Re: Revised Closure Permit Application for the Plant Gorgas Ash Pond

PERMIT APPLICATION FOR CCR SURFACE IMPOUNDMENT

PLANT GORGAS ASH POND

FIGURE NO
FIGURE 4

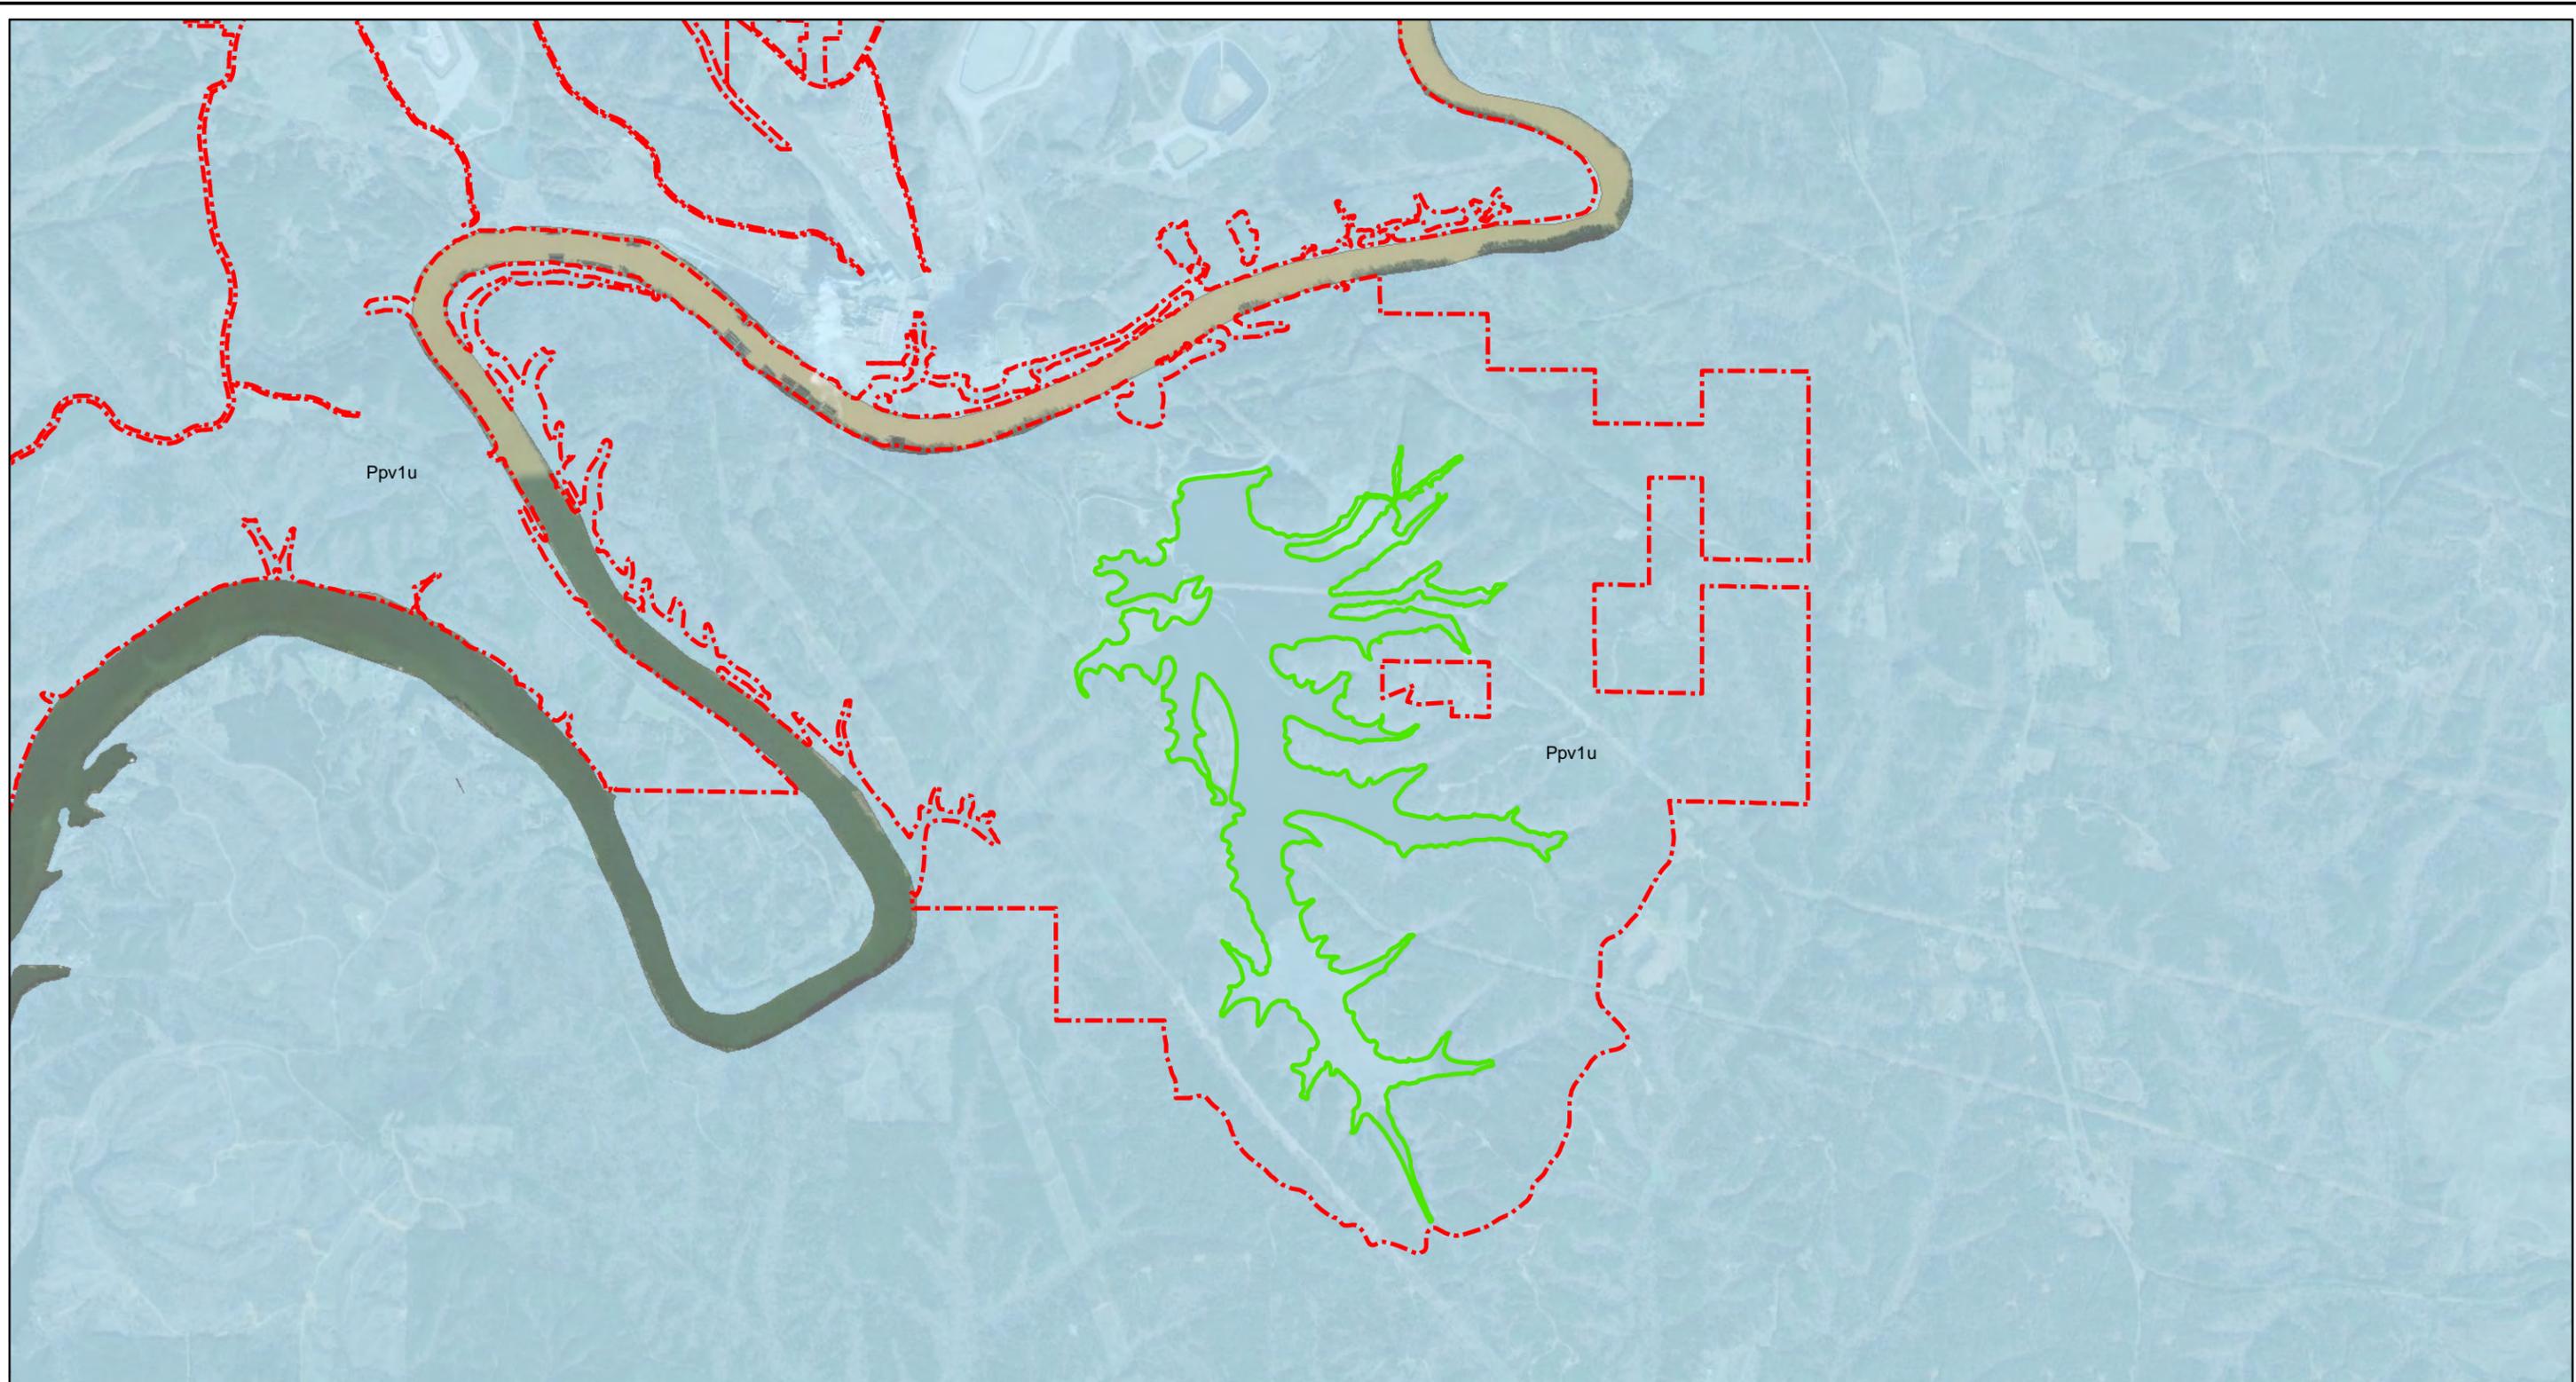
- 6. The faults depicted on figures 5A and 5b should be indicated on Figure 4.*

A revised figure including the faults is included in the attached *Supplemental Site Hydrogeologic Characterization Report*. Fault locations are included on Figures 3a and 3b of this report.

SCALE	As Shown	DRAWING TITLE	GEOLOGIC CROSS SECTION B - B' PLANT GORGAS ASH POND
DATE	4/14/2020		
DRAWN BY	KAR	FIGURE NO	FIGURE 5B
CHECKED BY	GBD

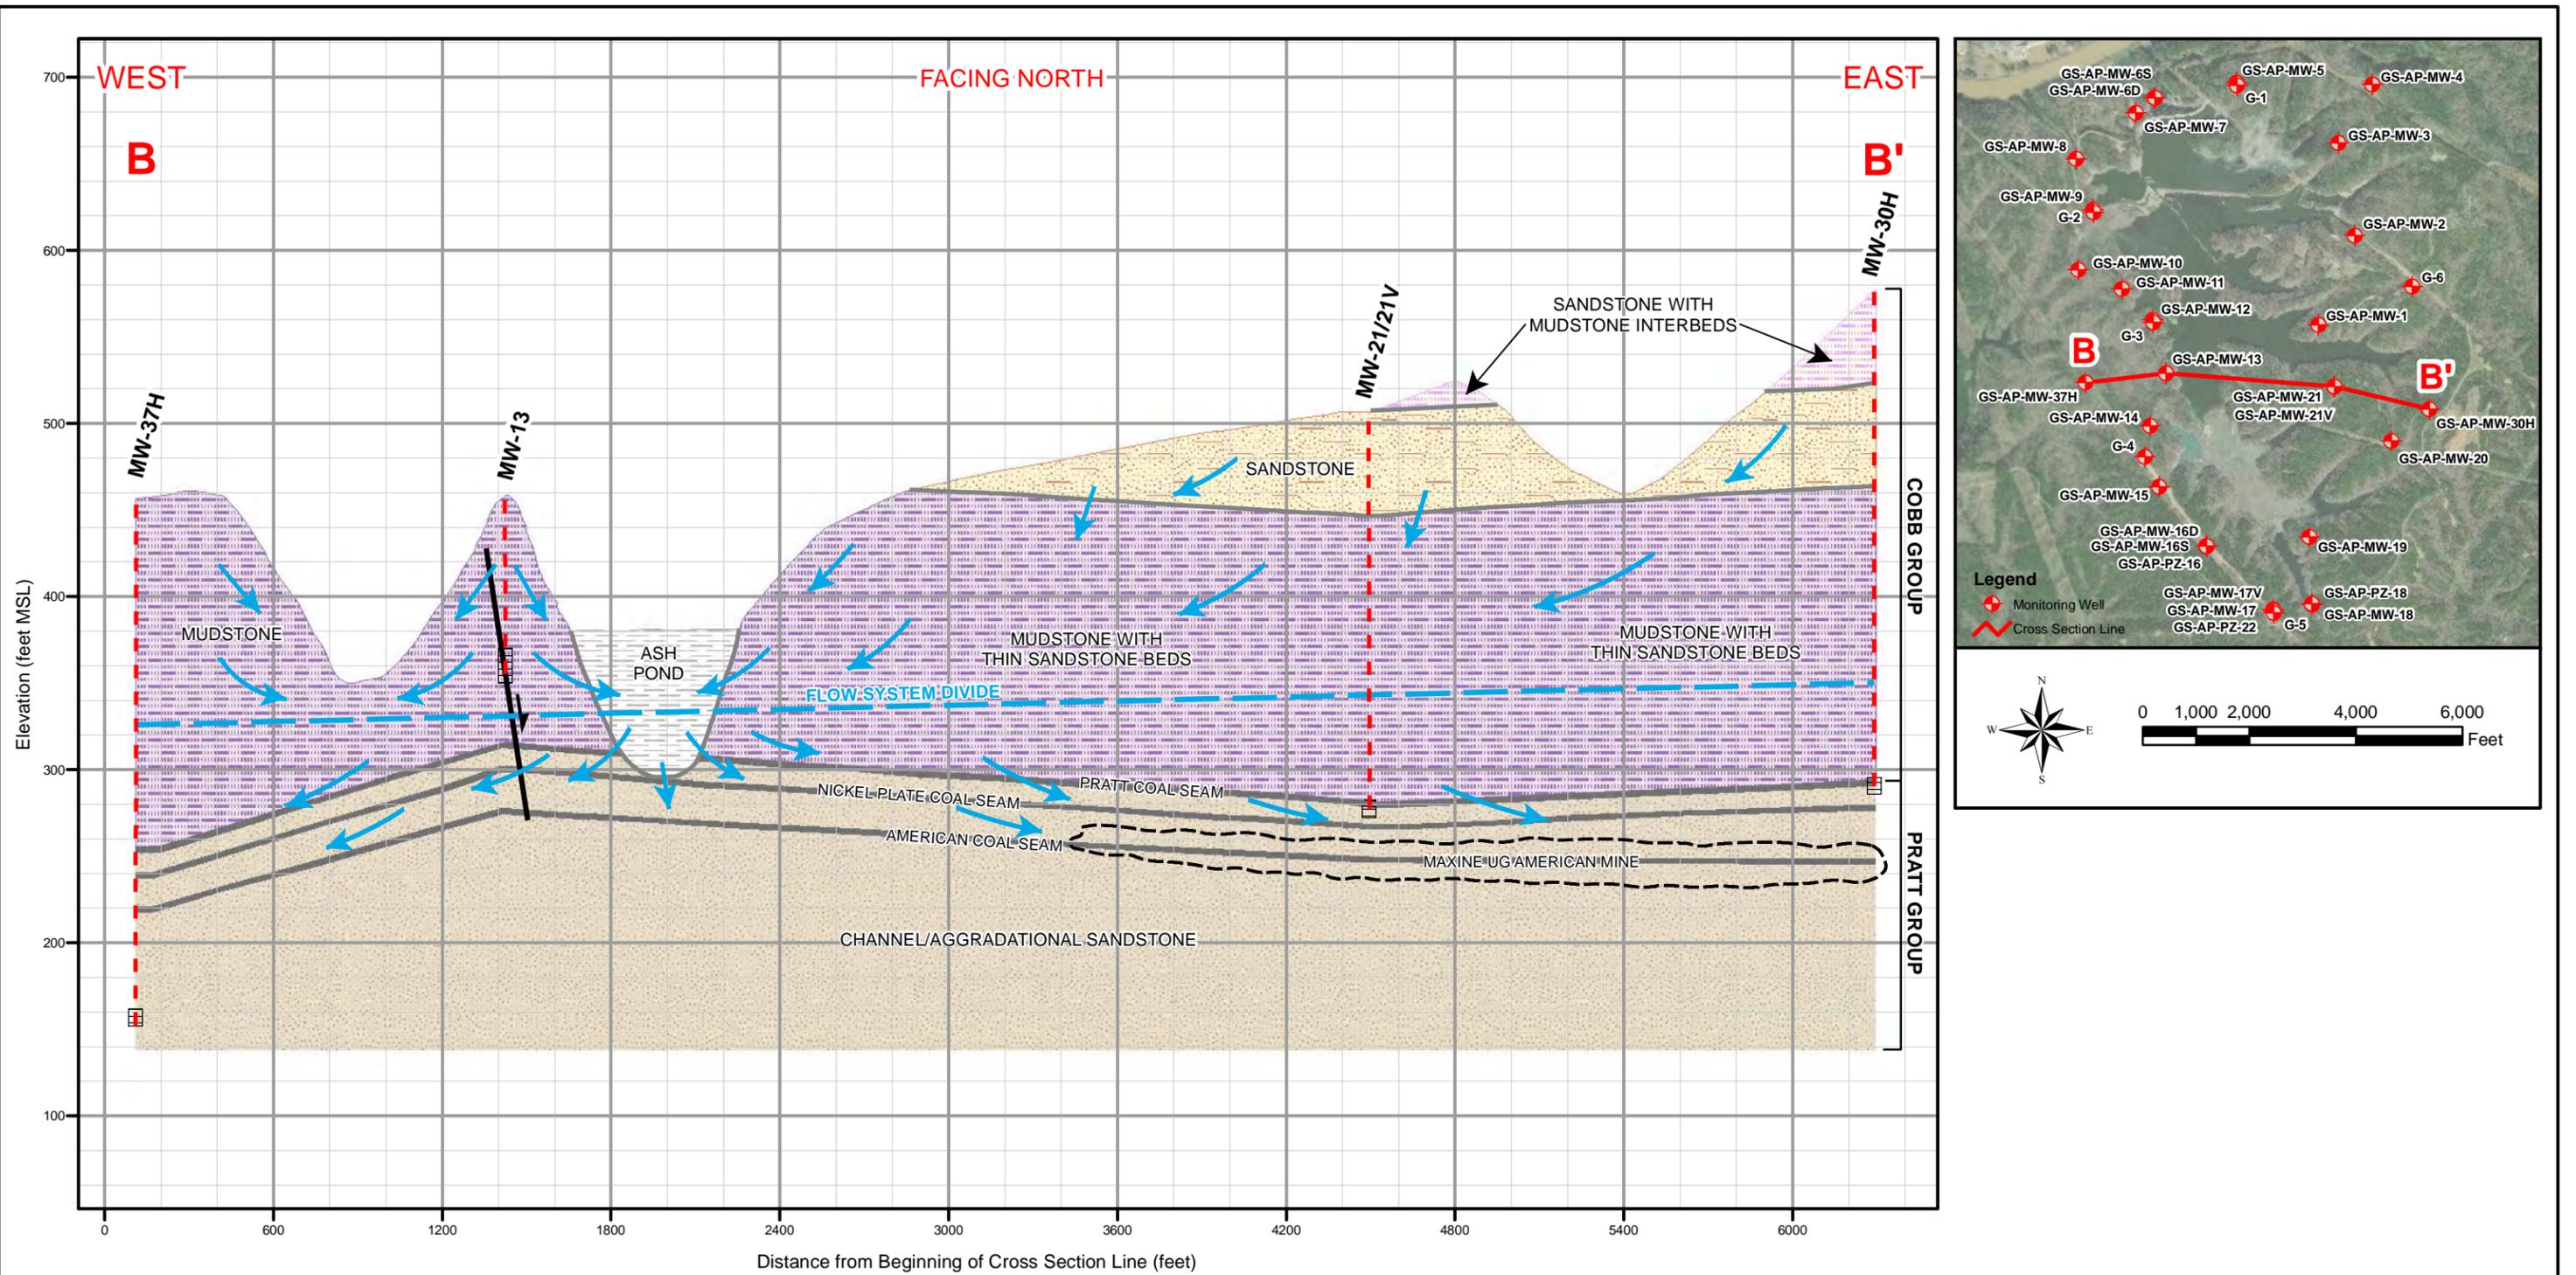
- 5. Two cross sections are included as Figures 5A and 5B to characterize the site. Additional detailed geologic cross sections across the Northern and Eastern portions of the site are requested to be included as part of the pending assessment of corrective measures plan to thoroughly characterize site conditions.*

The requested cross sections are included in the attached *Supplemental Site Hydrogeologic Characterization Report*. In addition, these cross sections presenting site stratigraphy and groundwater quality data were provided in the report titled *Semi-Annual Progress and Groundwater Delineation Report*, dated September 30, 2020. Figure 4D in the report presents a cross section along the eastern portion of the site. Figures 4F and 4H provide additional geologic interpretations along the northern and north-central parts of the site, respectively. Slight variability in groundwater quality is expected between monitoring events. These cross sections depicting groundwater quality data will be updated in subsequent semi-annual reports if groundwater quality changes and substantively alters interpretations of delineation.

DRAWING TITLE	
POTENTIOMETRIC SURFACE CONTOUR MAP (UPPER) WATER TABLE AQUIFER SEPTEMBER 23, 2019 PLANT GORGAS ASH POND	
FIGURE NO	FIGURE 6A

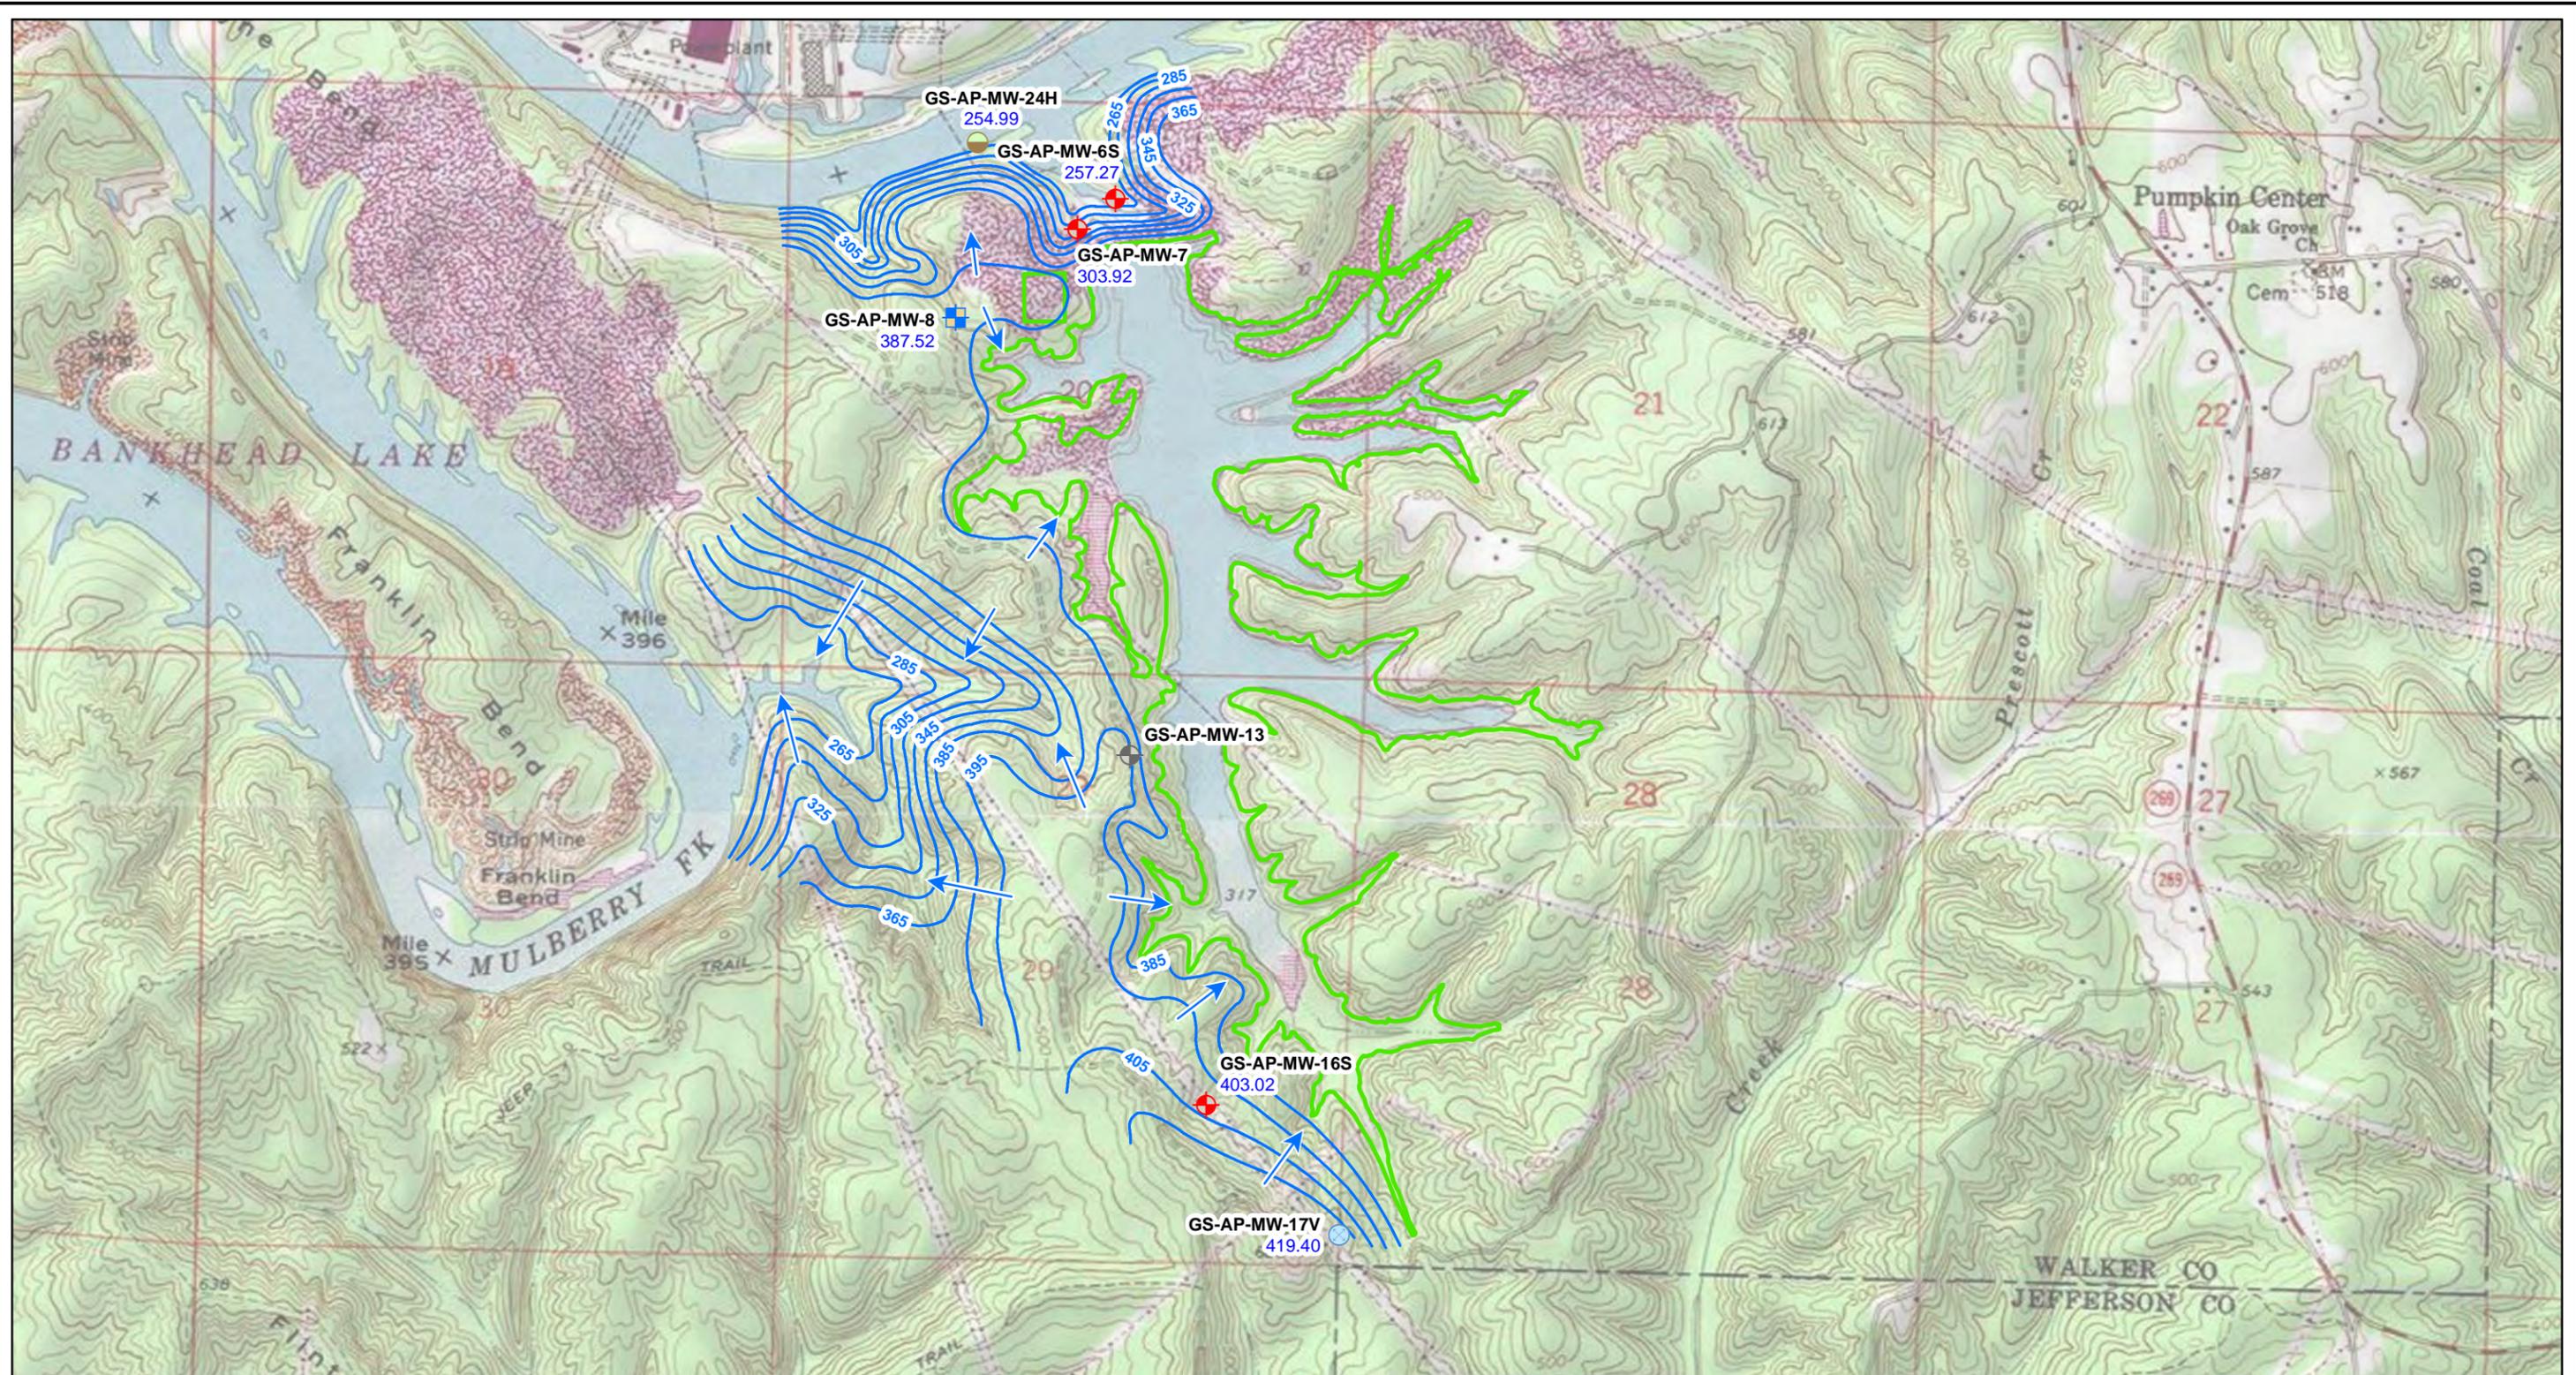
- 3. It appears that monitoring wells should be installed to monitor the (deep) Pratt Aquifer downgradient of the waste management unit between GS-AP-MW-15 and GS-AP-MW-25H in topographic low areas of the drainage feature depicted west of the site on Figure 6A.*

As requested by the Department, the figures and tables of the GWMP will be updated to identify current and planned wells so the monitoring network is sufficiently described for permitting purposes. Since submission of the GWMP to the Department, additional wells have been installed within the (deep) Pratt Aquifer. As presented on Figure 5 in the *2020 Annual Groundwater Monitoring and Corrective Action Report*, dated January 31, 2021, wells GS-AP-MW-37H and GS-AP-MW-39H were installed as part of delineation efforts at the site. However, as often occurs in the Pratt Aquifer, significant groundwater-bearing zones were not encountered, and the wells yielded insufficient groundwater for sampling. Also shown on Figure 5 are the locations of 4 wells that were abandoned pursuant to Department approval to facilitate pond closure work. These 4 wells are to be reinstalled when construction permits. A workplan and proposed replacement locations will be submitted to the Department by March 31, 2021. Well GS-AP-MW-12 remains in that area and is sampled semi-annually. Arsenic concentrations have steadily decreased in well GS-AP-MW-12 from 0.11 milligram per liter in August 2016 (mg/L) to 0.00616 mg/L during the most recent sampling event in September 2020. Concentrations have been below the GWPS during the last two sampling events. This steady decrease from the initial sampling event fits the description of chemical equilibrium restoring after the initial disturbance generated from the boring and well installation process.
